**Marion County
Board of County Commissioners**

**PLANNING & ZONING SECTION
STAFF REPORT**

P&Z Date: 10/27/2025	BCC Date: 11/18/2025
Case Number	251110ZP
CDP-AR	33323
Type of Case	Rezoning from General Agriculture (A-1) and Community Business (B-2) to Planned Unit Development (PUD)
Owner	Drake Ranch, L.L.C.
Applicant	Tillman & Associates Engineering, L.L.C. & Colalto Ranch Development, L.L.C.
Street Address/Site Location	13210 SW Highway 200, Dunnellon, FL 34432
Parcel Number(s)	40866-000-00, 41109-005-00, 41109-006-00, 41109-009-00, 41109-015-00 & 41109-017-01
Property Size/Project Area	±1,485.05 AC / ±446.72 AC <u>±407.40 AC</u>
Future Land Use	Rural Land (RL)
Existing Zoning Classification	General Agriculture (A-1)
Overlays Zones/Special Areas	Outside Urban Growth Boundary (UGB), Secondary Springs Protection Zone (SSPZ), Environmentally Sensitive Overlay Zone (ESZ), FEMA Flood Zone X/AE, Flood Prone areas present
Staff Recommendation	DENIAL
P&Z Recommendation	APPROVAL WITH AMENDED CONDITIONS

Figure 9
Proposed Modified Type C Buffer

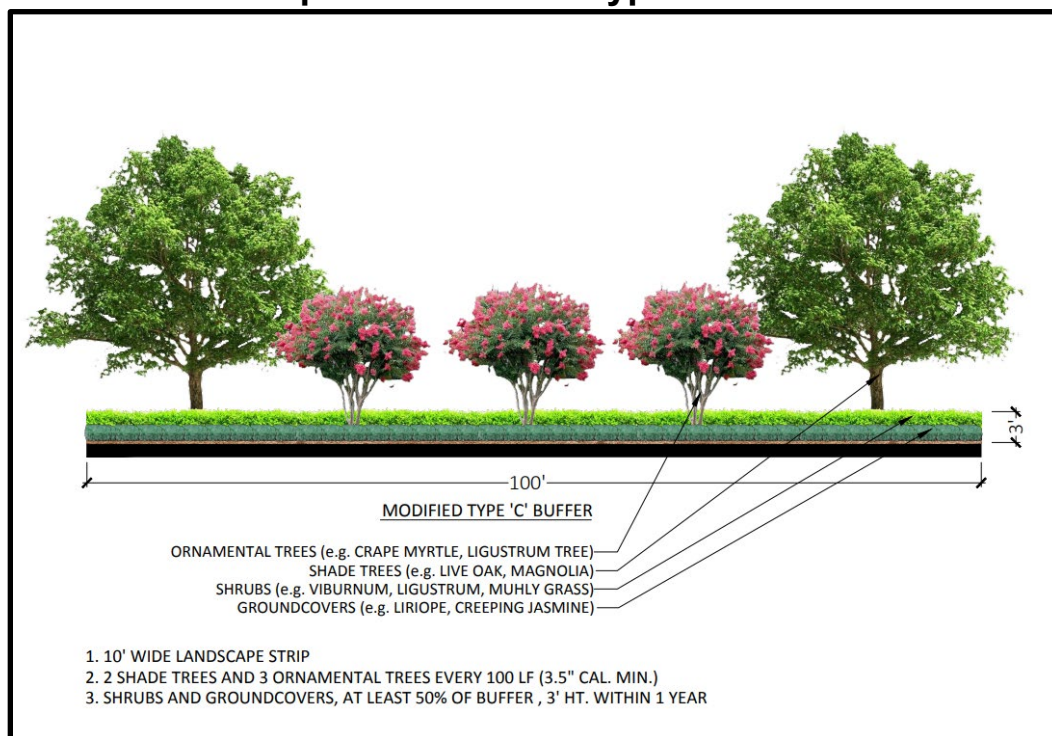
The applicant currently provides a modified Type C buffer consisting of a ten-foot strip without a buffer wall along only portions of the northern and eastern Project boundaries. Staff notes recreational vehicle (RV) and boat storage is proposed adjacent to this buffer. The applicant indicate landscaping/screening would be provided through a “Highway Vista Preservation Area” along S Highway 200 and a Linear Nature Park & Wildlife Corridor along the southern Project boundary, as indicated on the submitted PUD Concept Plan. Buffer details/diagrams are attached to this report (see Attachment D).

Staff notes that, in previous PUD cases, such storage areas have generally been required to provide more significant screening or relocate internally. Indeed, Staff notes such storage areas have been considered “commercial” for buffering/screening purposes. Section 6.8.6 of the Marion County LDC requires a fifteen-foot Type D buffer, composed of a landscaping strip *with* a buffer wall, on any commercial property boundary abutting an agricultural parcel. In addition, LDC Section 4.2.15 requires an opaque screen up to eight feet in vertical height for the outdoor storage of vehicles. Staff has concerns related to the opacity of the proposed modified Type C buffer understory to screen the storage area. Such understory is only proposed to reach a minimum height of three (3) feet in one (1) year.

- *External buffers shall be provided consistent with the submitted PUD Concept Plan (dated October 21, 2025) and the development conditions provided with this approval. All buffers shall be required at the time of development.*
 - *A Type D buffer shall be required along the proposed recreational vehicle (RV) and boat storage area.*
- *Within the Linear Nature Park & Wildlife Corridor area, trees shall not be removed without County approval. A Tree Preservation plan shall be provided during the submission of the Improvement Plan and shall not be deferred.*
